## APPLICATION FOR MODIFICATION ASSESSMENT REPORT

<b>Application Number:</b>	Mod2021/0883
----------------------------	--------------

<b>Responsible Officer:</b>	Anne-Marie Young
<b>Land to be developed (Address):</b>	Lot 2 DP 1248056, 25 - 27 Warriewood Road WARRIEWOOD NSW 2102
<b>Proposed Development:</b>	Modification of Development Consent D2020/0579 granted for construction of a Residential Flat Building, semi-detached dwelling, dwelling house and Community Title Subdivision, including internal private road
<b>Zoning:</b>	R3 Medium Density Residential
<b>Development Permissible:</b>	Yes
<b>Existing Use Rights:</b>	No
<b>Consent Authority:</b>	Northern Beaches Council
<b>Land and Environment Court Action:</b>	No
<b>Owner:</b>	J & G Knowles & Associates Pty Ltd
<b>Applicant:</b>	J & G Knowles & Associates Pty Ltd

*Proposed landscape plan*

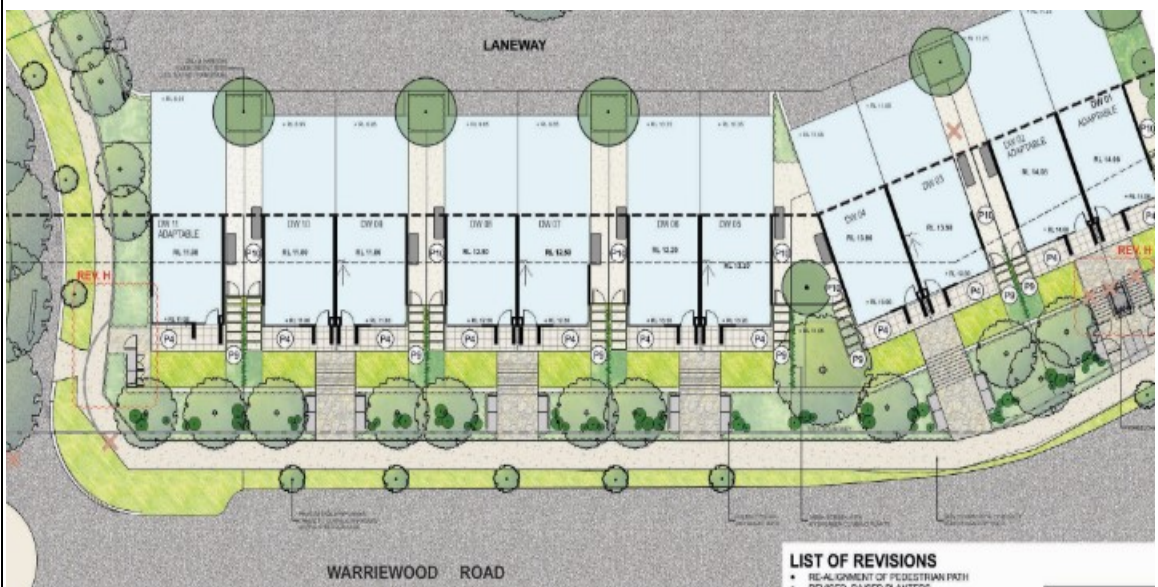
While it is appreciated that the front area has been approved as lawn in the previous application, the subject modification proposed paving along the side passage area of each town house, as shown below.

Internal Referral Body	Comments
	As such, it is agreed that the reduction in landscaping will reduce option to soften the built balance, the change to the landscape plan to allow paving area to the side passages are subject to the condition recommended by Council's Landscape Officer to delete the lawn dwellings 1-11 in lieu to garden beds.
NECC (Bushland and Biodiversity)	The proposed modification is acceptable in relation to the Pittwater biodiversity planning the comments and proposed landscape condition from Councils Landscape Officer.
NECC (Development Engineering)	No objections to the proposed Section 455(1a) modification . The proposes changes have the previous approved stormwater management plan and minimal change is required to the subdivision plan.
NECC (Water Management)	This application has been assessed against relevant legislation and policy relating to water areas, and groundwater. The proposed modification are including permeable pavement at the back of Dwellings 1 water quality targets of the approved development are maintained.

The indicated lawn areas in the Warriewood Road frontages of dwellings 1 to 11 inclusive shall be deleted and replaced with mass garden bed planting, consisting of native shrub planting installed at minimum 1 metre intervals of a minimum 200mm container size at planting, and native groundcover planting at 4 plants per metre square of a minimum 140mm container size at planting, and shall be in a garden bed prepared with a suitable free draining soil mix and minimum 50mm depth of mulch.

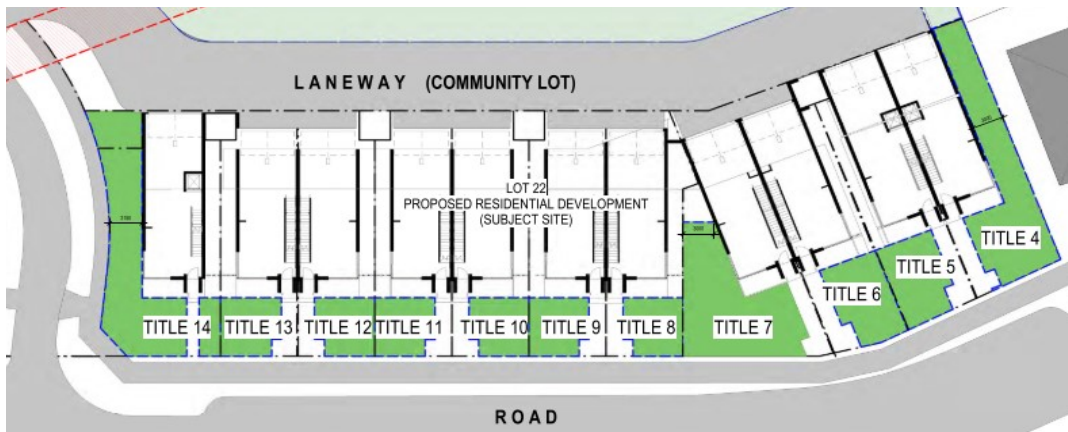
The proposal includes the change of the soft landscaping to permeable paving in the set backs to dwellings 1-11 which front Warriewood Road.

As discussed under Clause A4.16 a condition requires the lawns to dwelling 1-11 fronting Warriewood Road to be amended to garden beds to address concerns from Council's Landscape Officer relating to the reduction in soft landscaping associated with these dwellings, refer to discussion under the Referral section of tis report. The condition will ensure that the proposal achieves the requirement and following outcomes of the control.

*Section showing the platform lifts to dwelling 1 and 2*

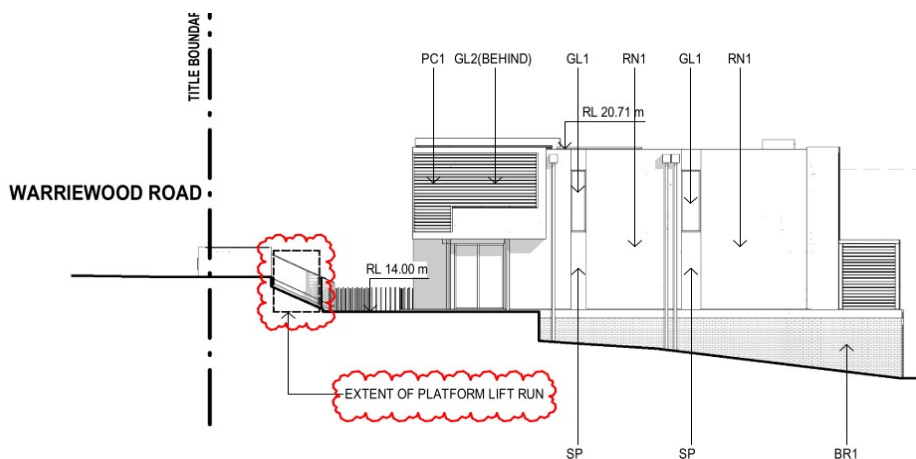
Dwellings 1 and 2 (lots 4 and 5) located in the eastern corner of the site are adaptable. In order to meet the accessibility requirements of the adaptable dwellings a platform lift is required to be installed within the front setback as there is a difference in the level between Warriewood Road and the frontage of dwellings, refer to image below.
